**Before the
Federal Communications Commission
Washington, D.C. 20554**

In the Matter of)	
)	
Expanding the Economic and Innovation)	Docket No. 12-268
Opportunities of Spectrum Through Incentive)	
Auctions)

REPLY COMMENTS OF ALCATEL-LUCENT

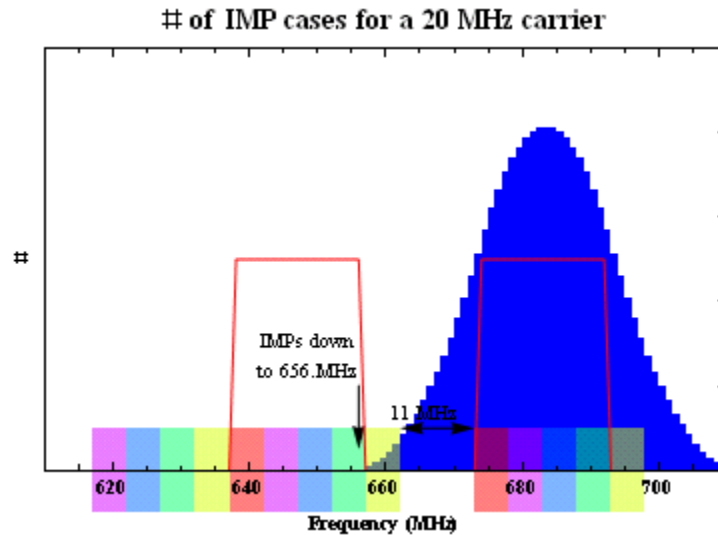
Google's and Microsoft's stated concerns that intermodulation interference requires a 28 MHz duplex gap also lack merit.²³ We have investigated whether a 600 MHz UE's transmitter 3rd order Intermodulation Products (IMP) or UE antenna path 3rd order passive IMP may fall into its own UE receive in-band and cause receiver desensitization, as Google and Microsoft claim. The illustration below, depicts an analysis of a worst-case 20 MHz carrier in a 25 MHz band, and shows that the 3rd order IMP are all above the corresponding downlink blocks, so will not cause any self-interference.

The 656 MHz IMP extent shown here does not extend into the 18 MHz occupied band.

For scenarios of 5, 10 or 15 MHz carriers, this engineering analysis finds that a 10 MHz duplex gap is sufficient to prevent the LTE UE transmitter/receiver 3rd order IMP or antenna path passive IMP from falling into its own UE Rx in-band. The carrier block position does not affect this calculation. To that end, Alcatel-Lucent included in its review 5, 10 and 15 MHz channels, as well as the unlikely case of a single operator winning a 20 MHz contiguous FDD block at auction. Only at 20 MHz channels, with all 18 MHz active resource blocks within the 20 MHz LTE channel assigned to a UE, does a 10 MHz duplex gap (located at 663-673 MHz) appear to be insufficient. Under those unlikely conditions, the 20 MHz LTE UE transmitter/receiver 3rd order IMP or antenna path 3rd order passive IMP will fall into 656-710 MHz which could cover the upper 1 MHz of its own UE Rx resource blocks at 639-657 MHz. This is at a weak tail of the IMP spectrum and only overlaps 5% of its band, so it may be acceptable. Even then, however, a duplex gap of 11 MHz would prevent the LTE UE 3rd order IMP or passive IMP from falling into its own UE Rx resource blocks – far short of the 28 MHz duplex gap proposed by Google and Microsoft. Higher order IMPs are weaker still and have not been seen to be problems in other bands.
